# REGIONAL REVIEW FINDING

**Submitting Local Government:** City of Atlanta  
**Name of Proposal:** Twelve 14th Street

Preliminary Report:	November 28, 2005	<b>DEVELOPMENT OF REGIONAL IMPACT REVIEW REPORT</b>	Project:	Twelve 14 <sup>th</sup> Street #937
Final Report Due:	December 28, 2005		Comments Due By:	December 12, 2005

**Re: Proposed Mixed Use Project for West Peachtree and 14<sup>th</sup> Street –  
Pope & Land/Novare Group Joint Venture  
Revised Variation Requests**

TITLE: **TWELVE AT 14th STREET DRI SITE PLAN**

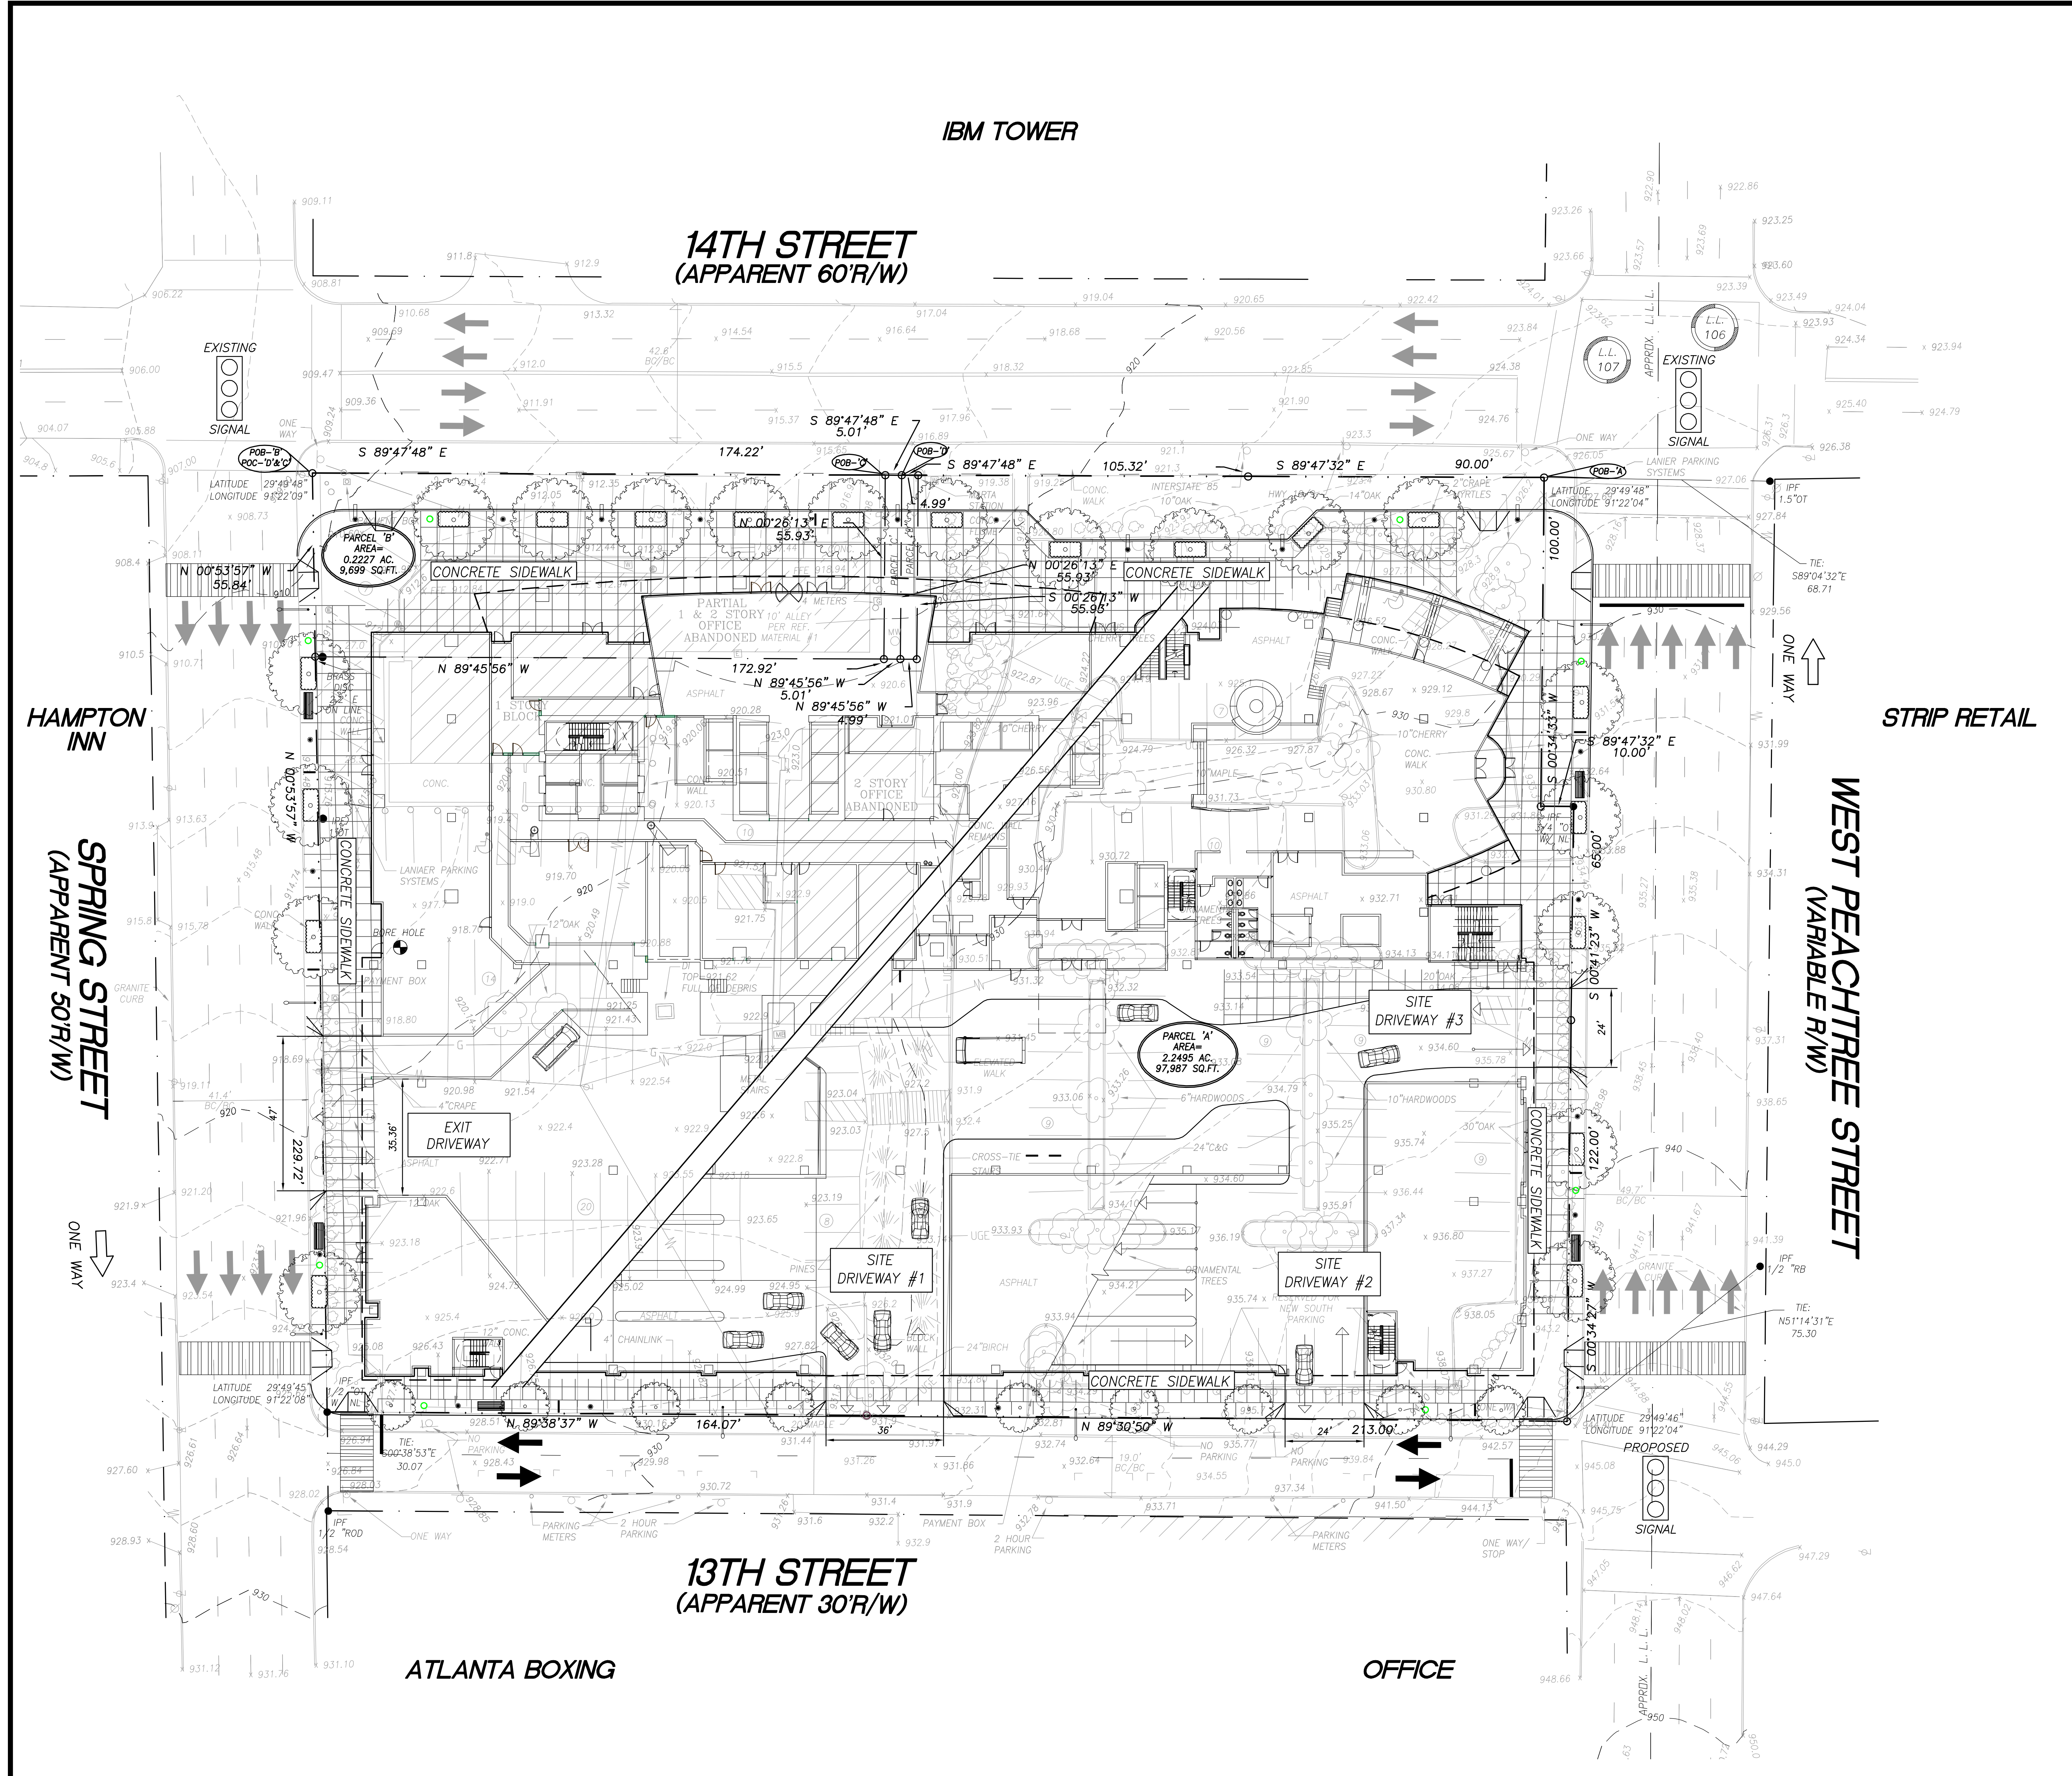
The development proposes access onto West Peachtree Street. The Downtown Midtown Bus Circulation Study recommended implementing a bus contra-flow lane on West Peachtree Street from 17th Street to Pine Street in Midtown Atlanta. At the completion of the study, the Downtown Midtown Bus Circulation Study Green Light Implementation Team was formed to ensure the timely implementation of all recommendations. At the first meeting, held on December 8th, 2005, it was decided that a more detailed traffic engineering analysis (simulation model) of the street grid system in Midtown is necessary before starting any preliminary engineering work to ensure the contra-flow lane is feasible on West Peachtree Street. At this time, no future studies are slated or funds established to conduct this study. Once funding is established, the Green Light Team hopes to start this additional work. Also, the study does not recommend prohibiting additional curb cuts along this section of West Peachtree Street.

Every effort should be made between the City of Atlanta, Midtown Alliance, and the developer to ensure that impact to the right of way along West Peachtree Street is minimal. This should include the exclusion of taxi stands, limousine pullouts or any other infrastructure that would impede the efficiency of the contra-flow bus lane.

**West Peachtree Street at 13<sup>th</sup> Street**

- Add a traffic signal to allow vehicles on 13<sup>th</sup> Street to safely and efficiently turn onto or cross West Peachtree Street.

**Spring Street at Exit Only Driveway**

- Add an entering lane into the deck. This removes turning vehicles that will access the site via 13<sup>th</sup> Street.
